Title: **STAGE 1 ROAD SAFETY AUDIT**

**Proposed Residential Development, Greenhills Road,  
Walkinstown, Dublin 12.**

Client: **Lohan & Donnelly Consulting Engineers.**

Report reference: **1353R01**

Drawing 20189-LDE-07-00-DR-SC-1C03 Rev P, Vehicular access onto Greenhills Road.

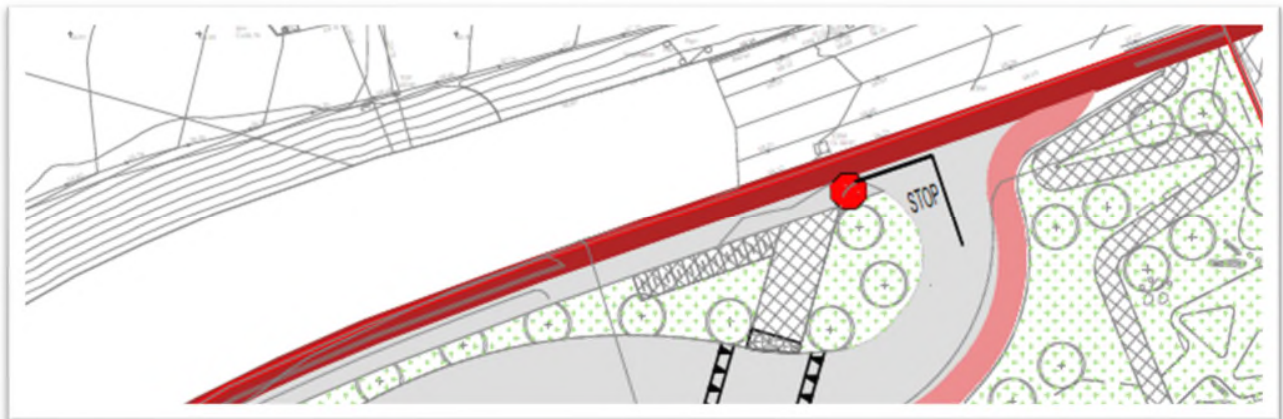
There is a vertical crest curve on Greenhills Road to the west of the proposed access. There is a risk that this may obscure visibility of drivers exiting the development to oncoming eastbound vehicles on Greenhills Road resulting in side-impact or rear-end collisions.

It is recommended that the visibility be checked in the vertical plane to ensure sufficient visibility is available.

3.1	Yes	Yes - We have checked (in accordance with the requirements outlined in DMURS) and provided visibility splays drawing for the entrance/exit junction into the development. It was determined that drivers have sufficient visibility when exiting the development. Furthermore, the existing high fence along the northern frontage of the development obscuring the view of upcoming traffic travelling southbound will be demolished and replaced with a lower, more user friendly from a visibility point of view vehicle restraint system.		Yes

Drawing 20189-LDE-07-00-DR-SC-1C03 Rev P, Cycle Lane at Greenhills Road.

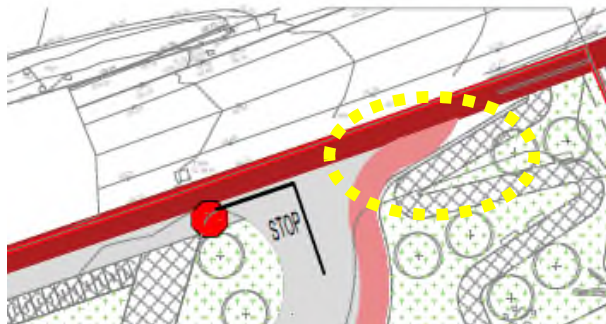
Cyclists exiting the development and wishing to travel towards the Walkinstown Roundabout may have difficulty crossing Greenhills Road to access the advisory cycle lane given the high traffic volumes. This may result in cyclists travelling on the footpath or contra-flow on the outbound cycle lane where there would be an increased risk of collisions with pedestrians or other cyclists.

It is recommended that crossing facilities for cyclists (and pedestrians) be provided on Greenhills Road.

3.3	Yes.	Yes. – A vehicle dwell area of 2.4m in length has been provided with a fall of 1/25 (i.e. 2.29 degrees).		Yes
3.4	Yes.	Yes. – An uncontrolled 4.0m wide pedestrian/cyclist crossing		Yes

has been introduced west off the main entrance/exit access point to the development.		
3.5	No.	No.	Existing southern access road will have an average width of 6.5m across the full extent of our site upon completion of the development. In accordance to DMURS a 6.5m road width is suitable and has sufficient space for heavy goods vehicles to simultaneously use the road. It's important to note that the existing footpath (on side facing our site in question) of the existing southern access road will be omitted and instead used as road space upon completion of the development.	Yes

Appendix A – Problem Location Map

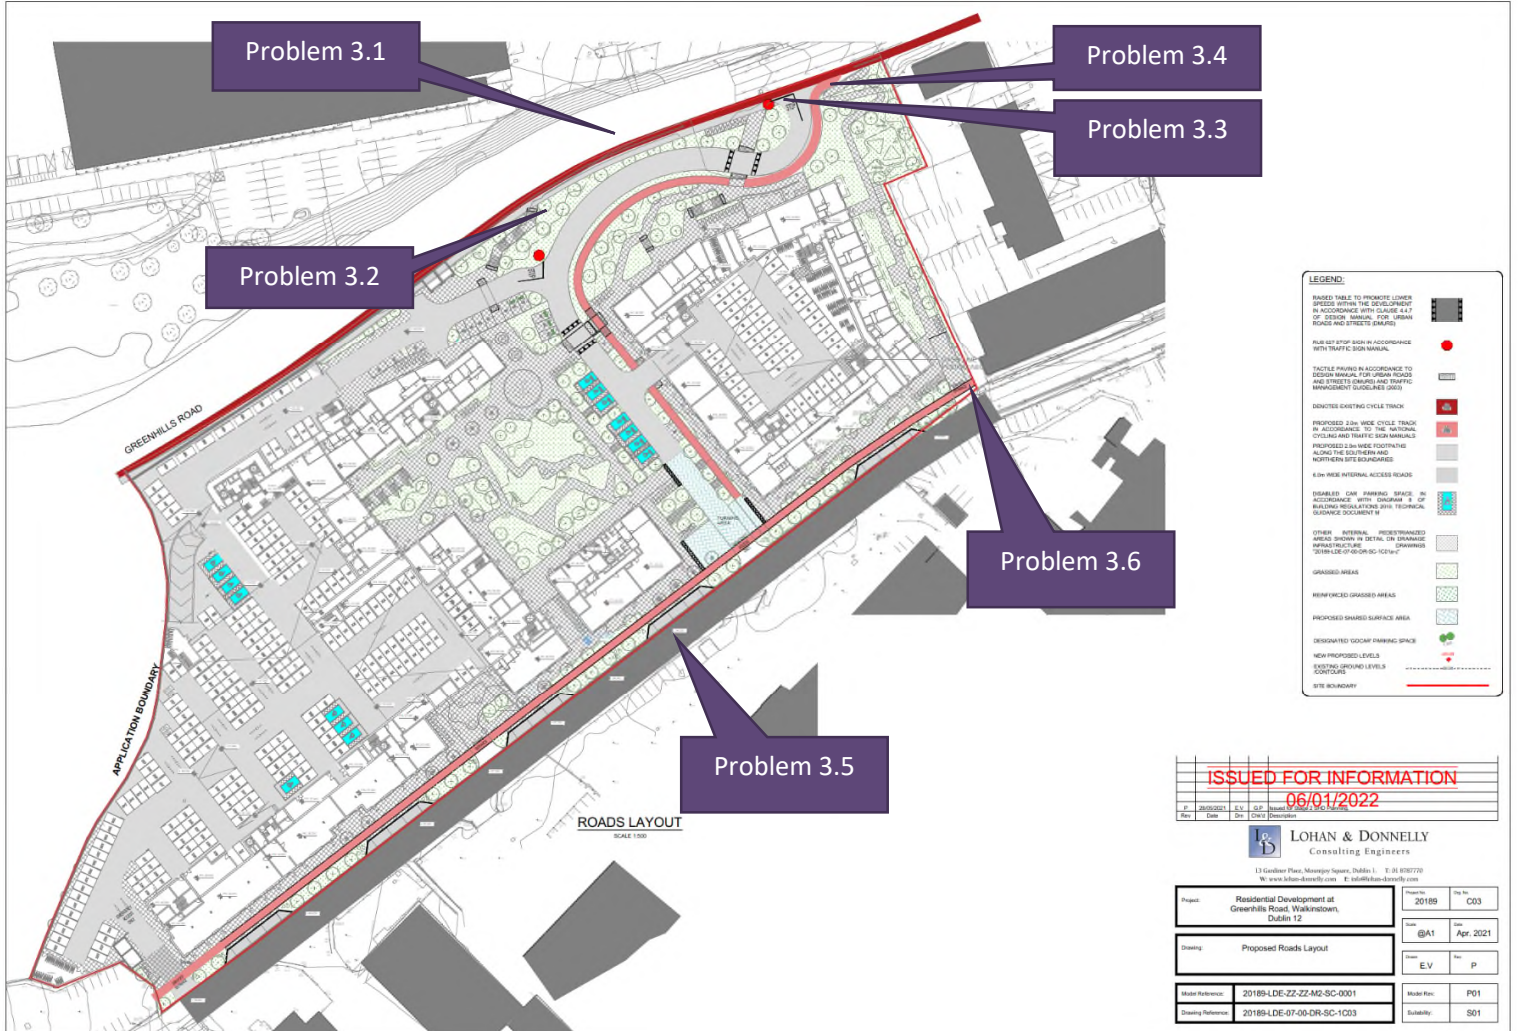
It is unclear what retaining/containing features, if any will be provided along the southern boundary of Greenhills Road. There is a height difference between the Greenhills Road and the internal development road. There is a risk that an errant vehicle on Greenhills Road will descend the embankment resulting in high injury severity.

It is recommended that a risk assessment be carried out to determine if a vehicle restraint system is required and if so what level of containment.

It is unclear if a suitable dwell area has been provided at the vehicular access given the lower height within the development. If there is a steep uphill gradient onto Greenhills Road there is a risk that drivers may not get sufficient traction to accept gaps in traffic resulting in side-impact collisions or sudden acceleration and loss of control.

It is recommended that a dwell area with suitable gradients be provided.

The industrial road at the south of the site is relatively narrow and has a high usage by heavy goods vehicles. There is a risk that vehicles will not be able to pass especially when cars are parked in the parallel parking spaces. This could lead to side-swipe collisions.

It is recommended that a swept path analysis be carried out to ensure that heavy goods vehicles can pass each other and turn at industrial accesses along the back lane.

It is proposed to provide a cycle track parallel to the back lane. This cycle route terminates at the site boundary without connectivity to the internal cycle network. There is a sharp 90 degree bend on the back lane that has limited visibility to/from cyclists. There is a risk that the proposed parallel cycle track may lead to greater cyclist numbers at this severe bend and therefore greater risk of collisions with commercial/industrial turning traffic.

It is recommended that the cycle track be omitted or connected to the internal cycle network.

3.2	Yes	Yes. – A vehicle restraint system will be provided along the entire extent of the northern frontage. Type of vehicle restrain system used to be determined at detailed design stage.		Yes

3.6	No.	No.	It has been specifically requested by SDCC that we have both a footpath and a cycle lane along the northern & southern frontages of the development. Cyclists traveling on the southern cycle track can exit the development via the internal cycle track traversing the site and out the primary exit/entrance point located north-east of the development.	Yes
